INSTALLATION OF CUSHION BARRIER
AT LUNALILO FRWY - VINEYARD (OFF-RAMP)
& STA. 83+00
SAFETY IMPROVEMENTS ALONG
INTERSTATE H-1
KALIHI ST. TO PALI HIGHWAY
Proj. No. I-HI-1(112):19 Date: April, 1973

STATE OF HAWAII
DEPARTMENT OF TRANSPORTATION
HIGHWAYS DIVISION
INSTALLATION OF CUSHION BARRIER
AT LUNALILO FRWY. & RAMP "5"
@ Sta. 103+50
SAFETY IMPROVEMENTS ALONG
INTERSTATE H-1
KALIHI ST. TO PALI HIGHWAY
Proj. No. I-H-1(112)19 DATE: April, 1973

C. O. 45

SAFETY IMPROVEMENTS ALONG
INTERSTATE H-1
KALIHI ST. TO PALI HIGHWAY

TYP. SECT. THRU 4" CONC. CUSHION BARRIER SLAB

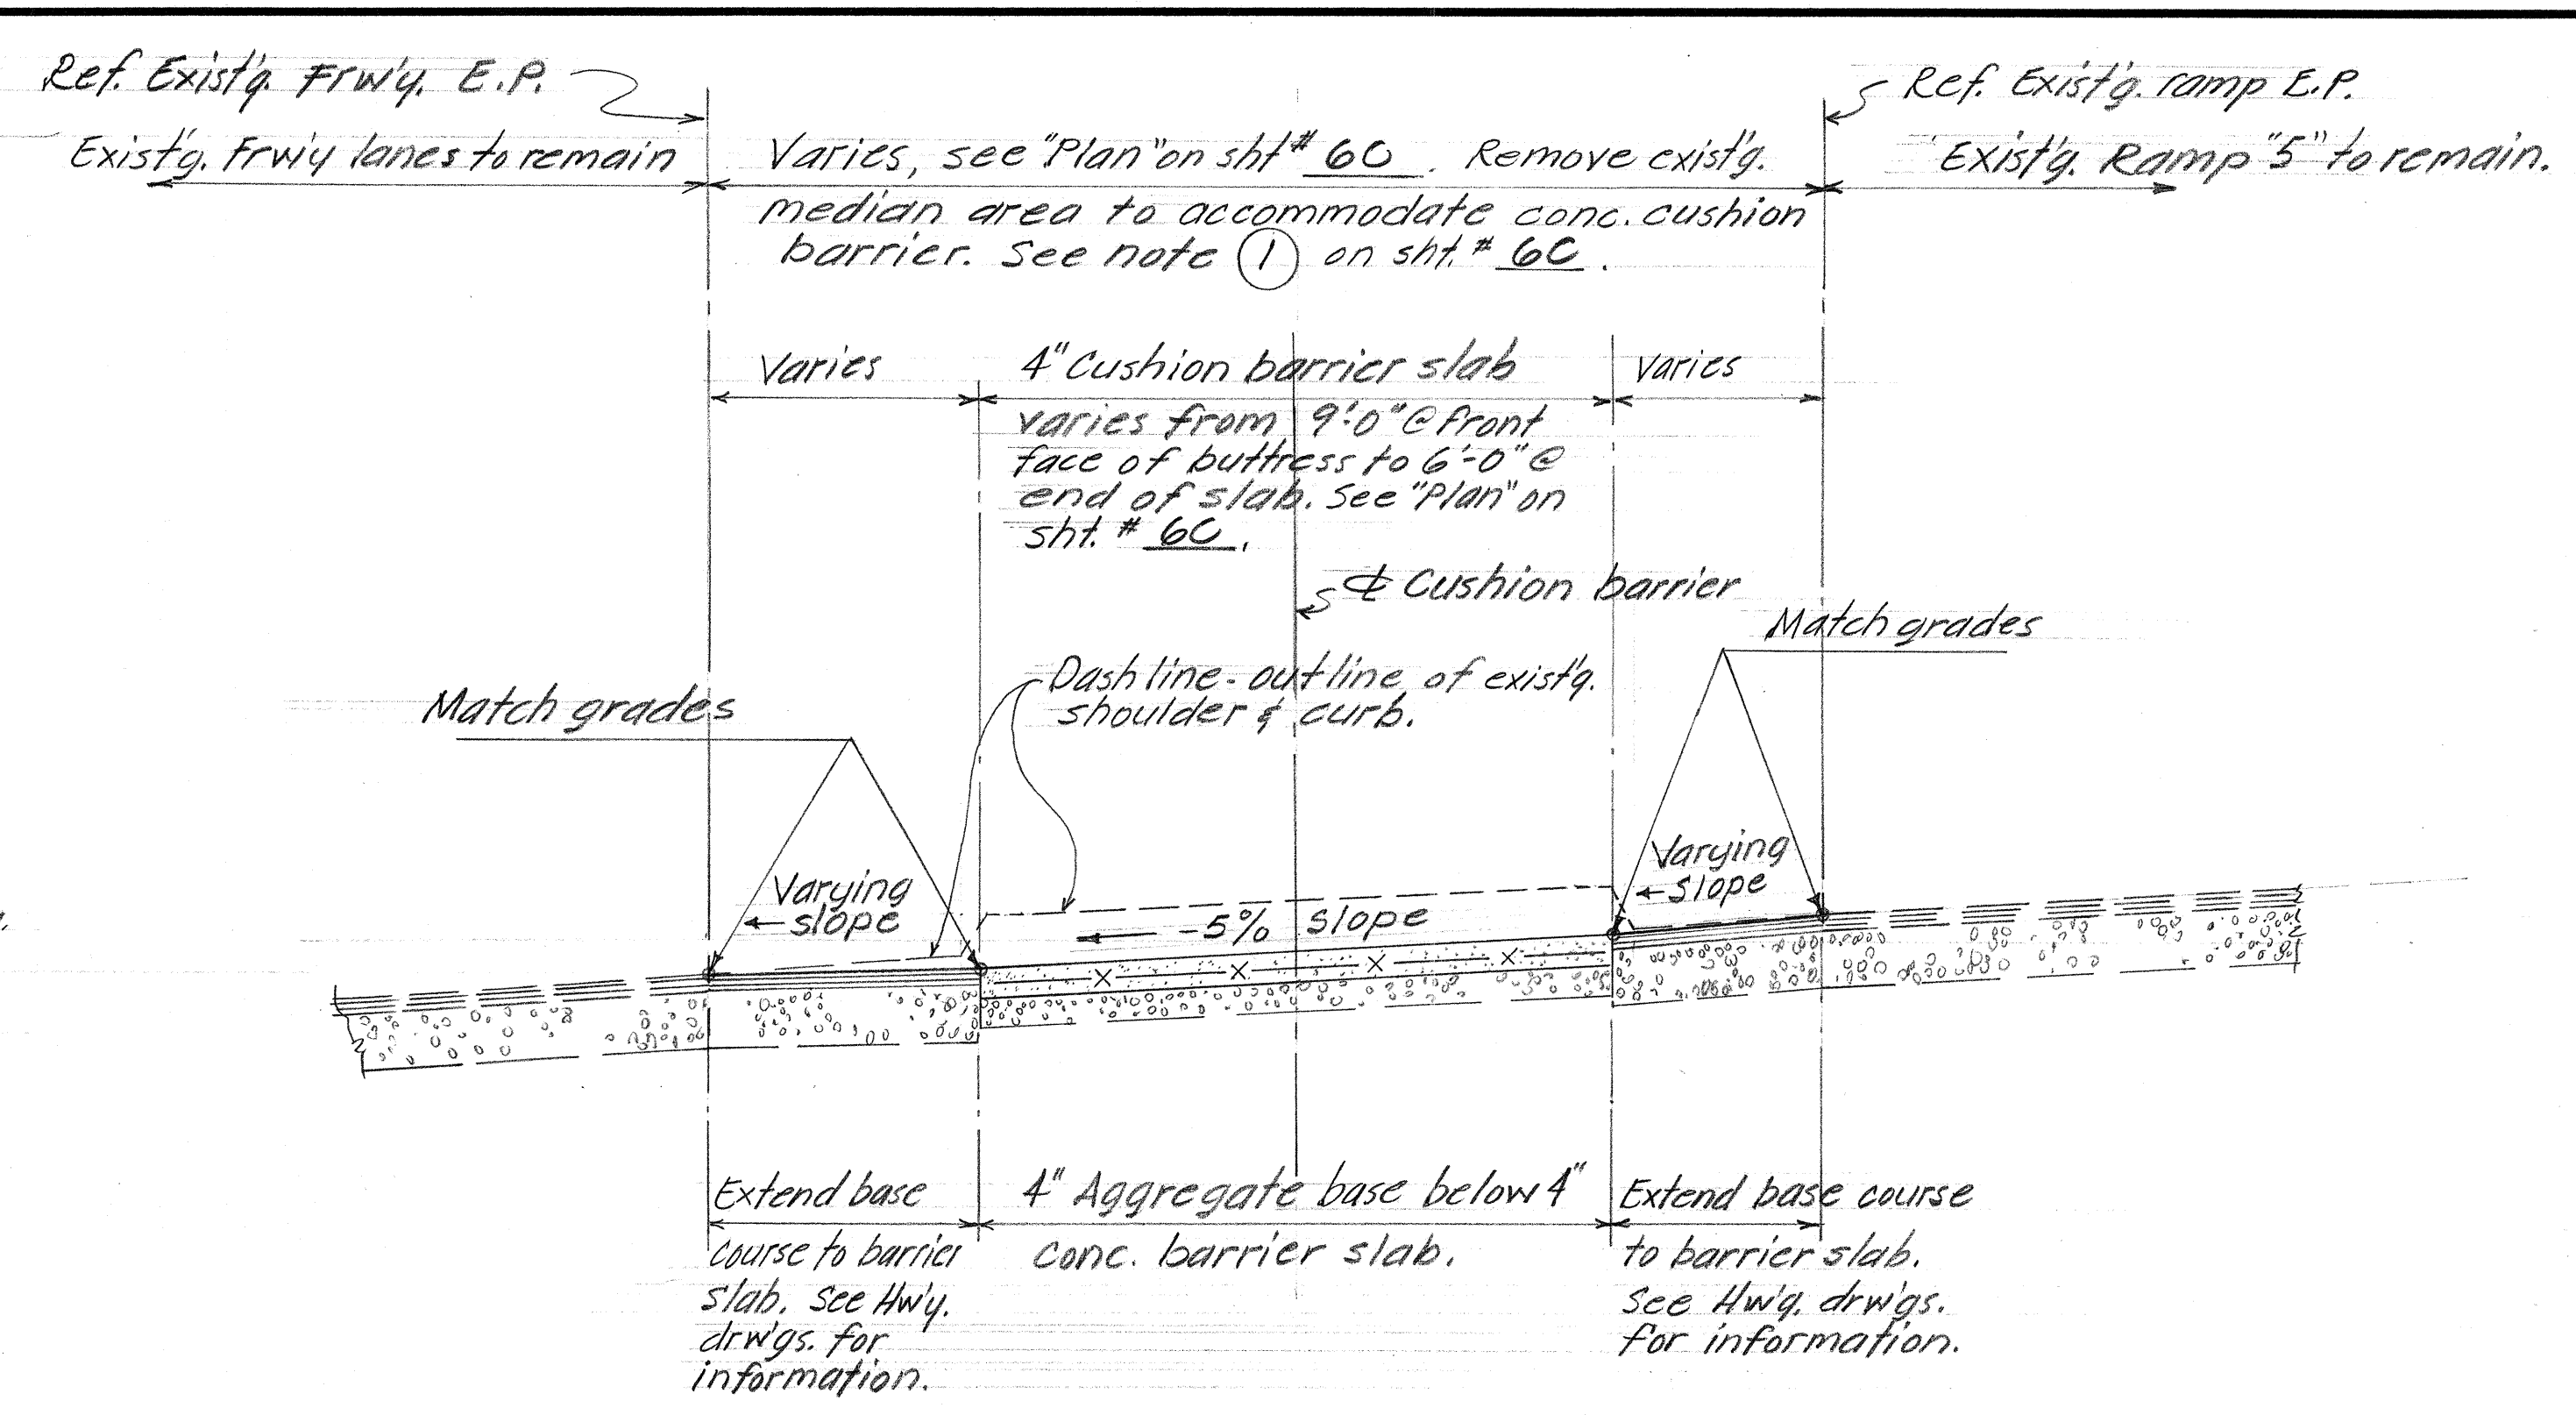
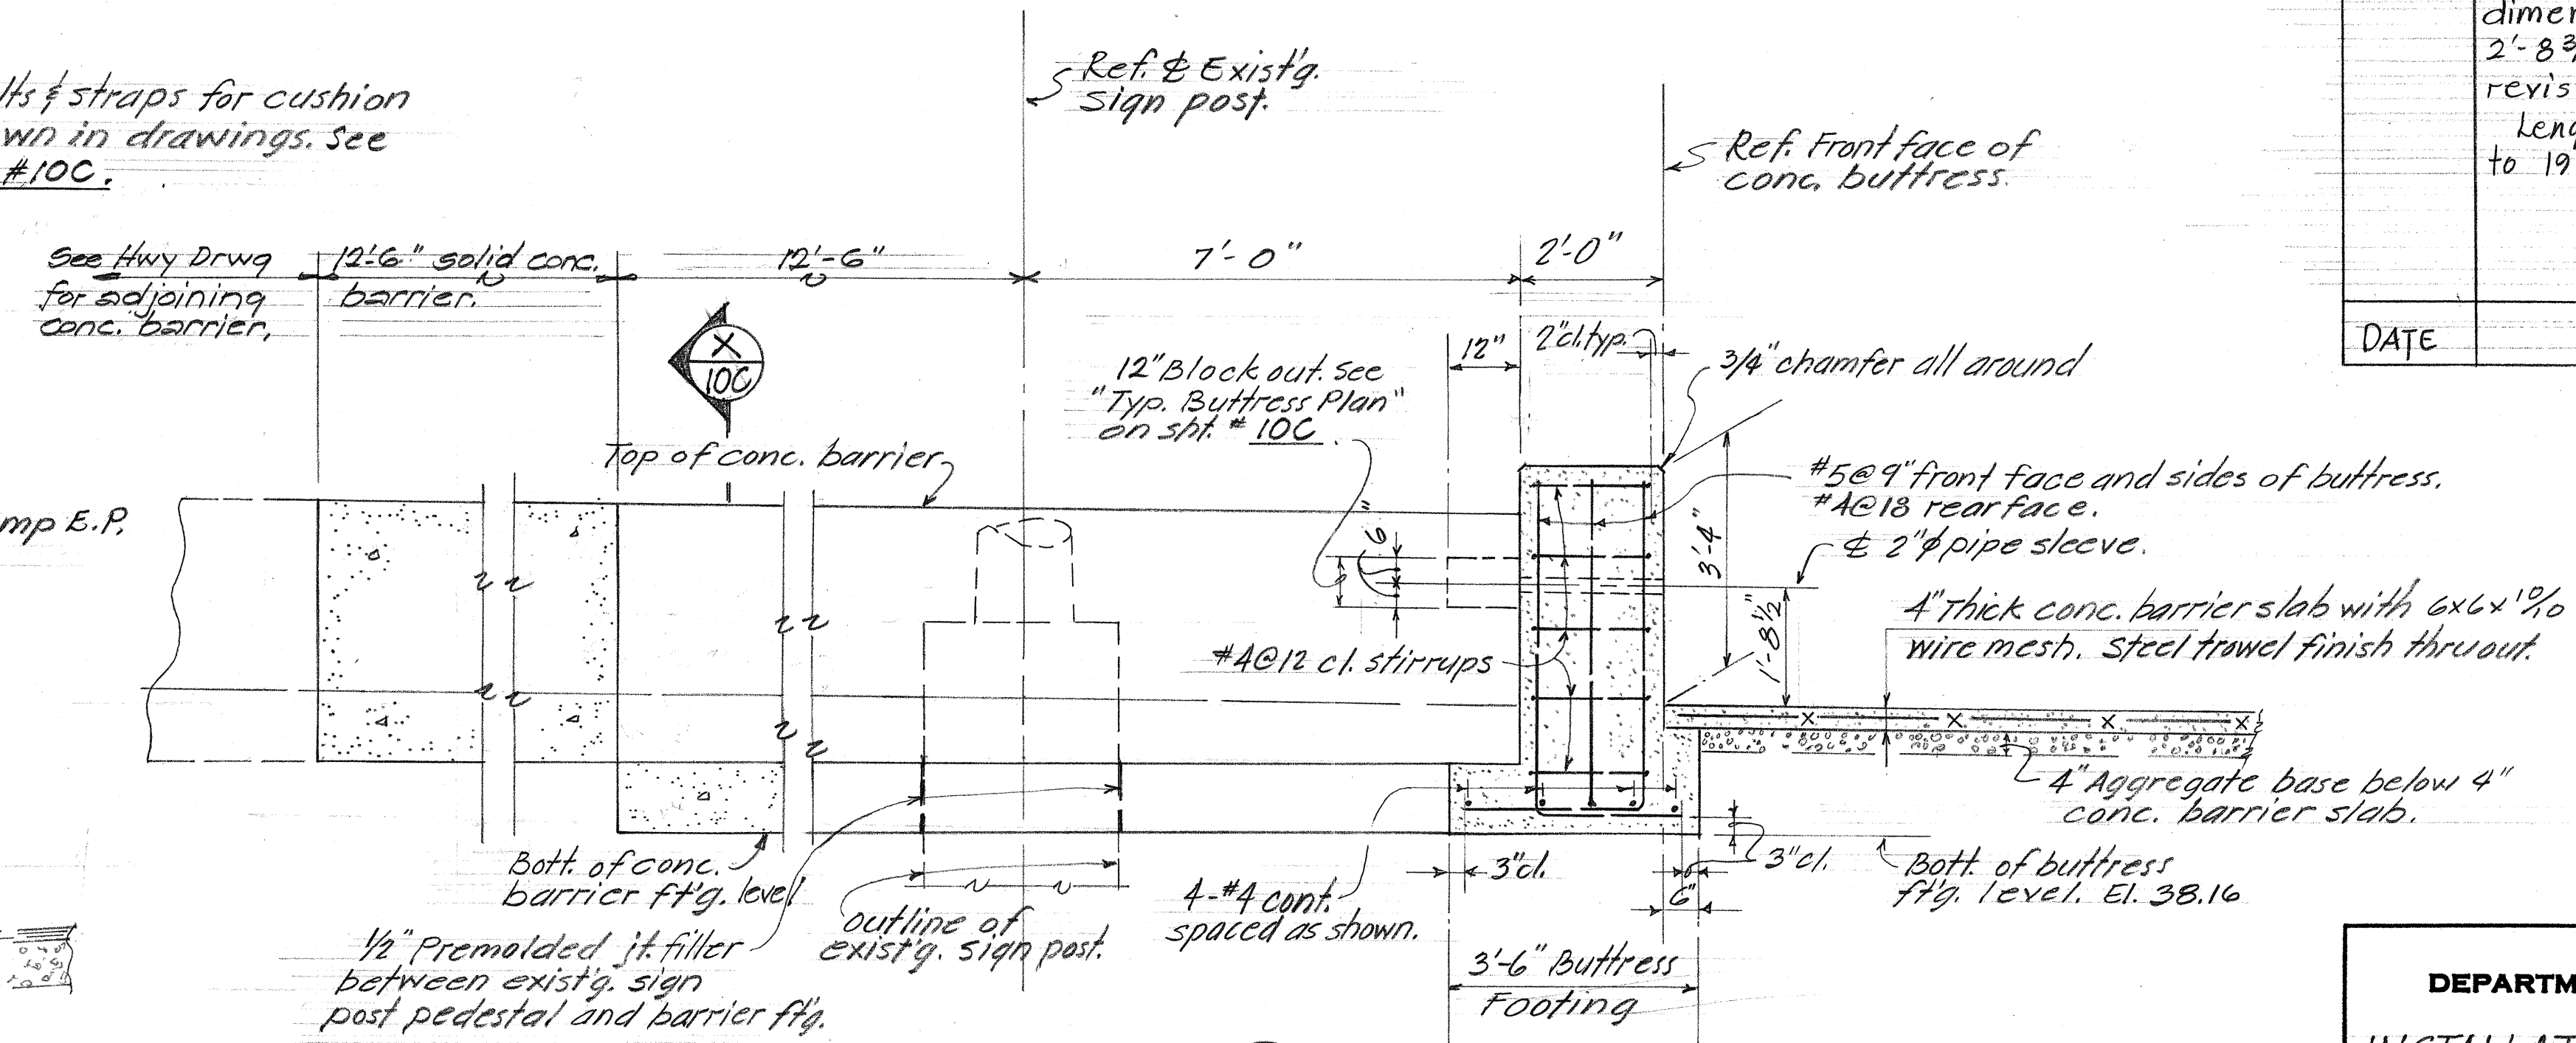
12-6-74 Restraining cable 2" pipe sleeve dimension changed from 2'-8 1/4" to 2'-8 3/4" and block out dimension revised. Length of unit changed from 21'-2 1/4" to 19'-11 1/2".
